February 5, 2002
NRC:02:011

Responses to an Informal Request for Supporting Information

INFORMATION NEEDED FOR CFL BREAK REVIEW, TAC MA9973

Figure 1

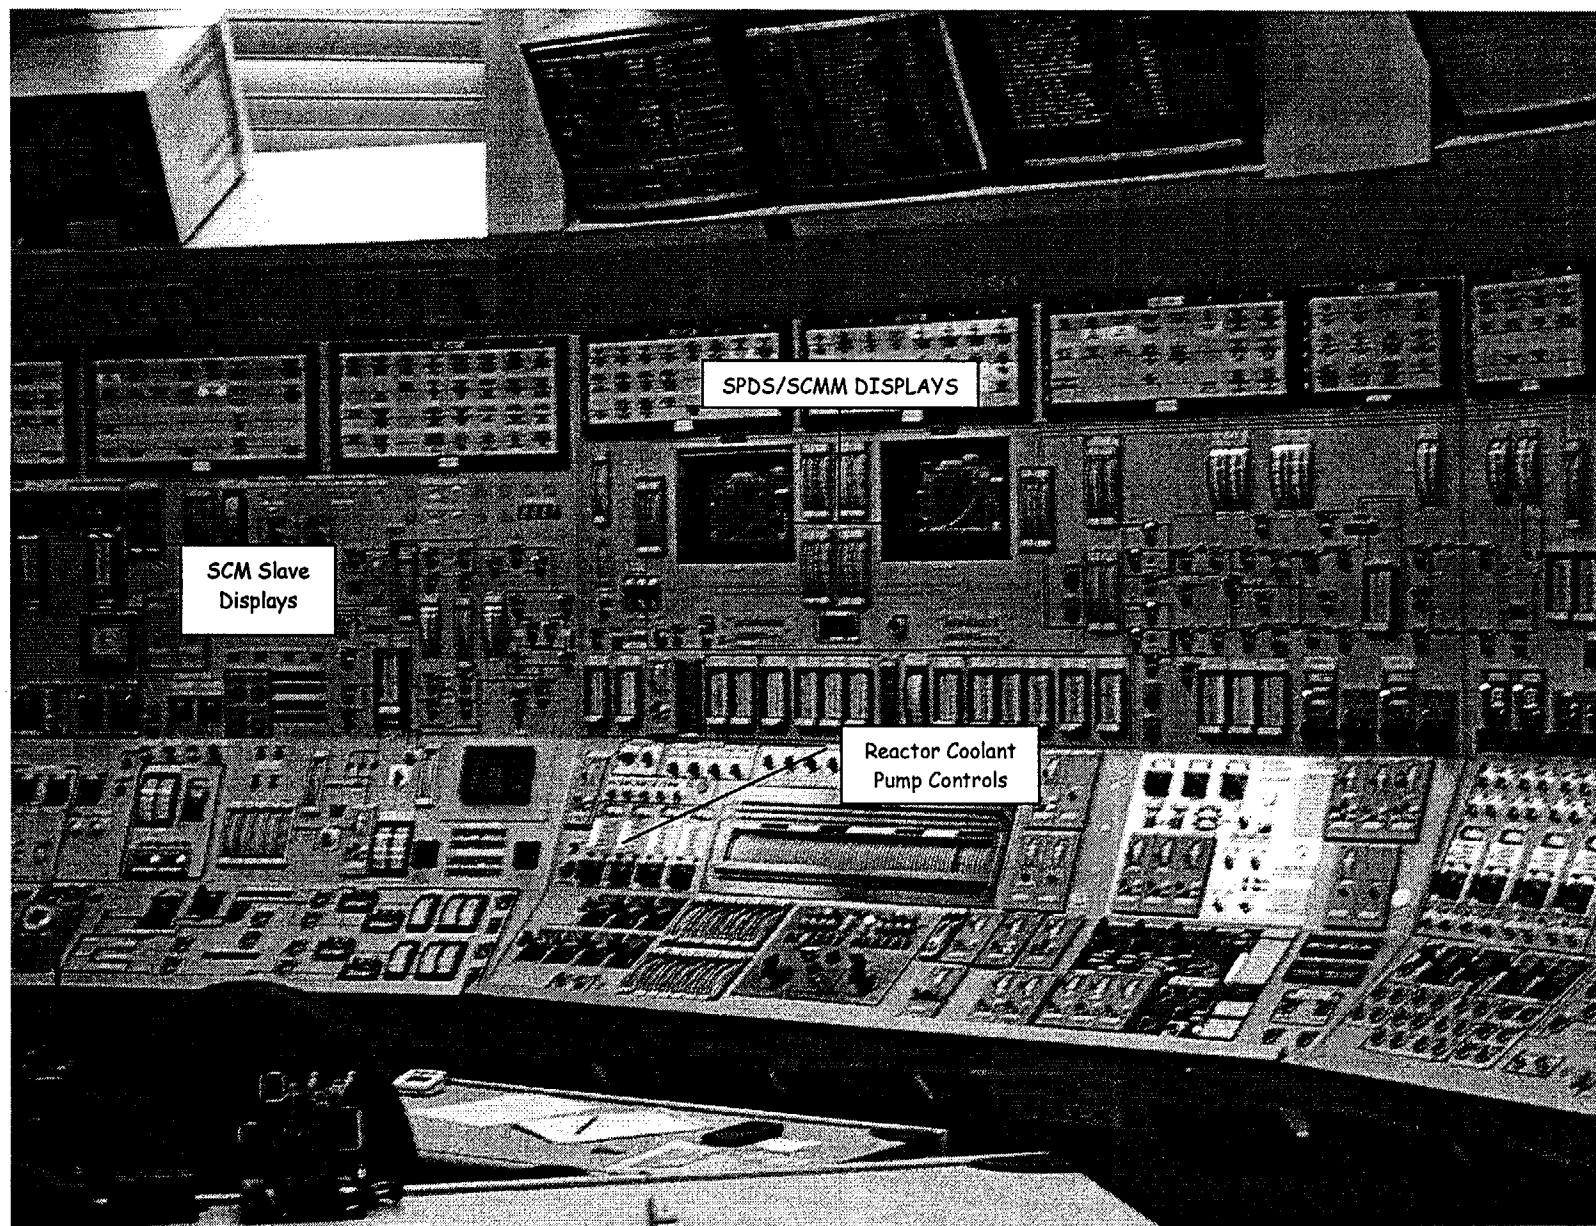
2. **Identify the information needed by the operators and describe how the information is provided visually and audibly. Address the safety “pedigree” of the applicable displays and describe alternates, including operator response, if the primary information sources are lost. Include photographs of the key visual information sources.**

The SPDS/SCMM displays are located on the main control board directly above the reactor control panel (see Figure 1). The subcooling margin (or degrees superheat) presented on this display is calculated using inputs from RCS Loop A or B pressure, and either T_{hot} or T_{incore} , as selected by switches on the SPDS control panel. Following a reactor trip the Subcooling Monitor automatically transfers to T_{incore} as the preferred temperature input.

In addition to the primary SPDS displays, two Subcooling Margin Monitor Slave Display units are mounted on the PSA section of the main control board (see Figure 1 and 5). These units provide a duplicate display of the SPDS subcooling margin. The slave displays can be used to monitor SCM if the SPDS CRTs were to fail however they are dependent on their associated SDPS computer for intelligence.

Reactor Coolant Pump control switches are located on the main control board below and to the left of the SPDS displays (see Figure 1 and 6). The RCPs are controlled by standard General Electric Type SBM pistol grip control switches. To stop an RCP motor the control switch is selected to the "STOP" position. If an individual RCP motor breaker were to fail to open on command, the pump can also be stopped from the main control board opening the feeder breaker to the electrical bus powering the affected RCP.
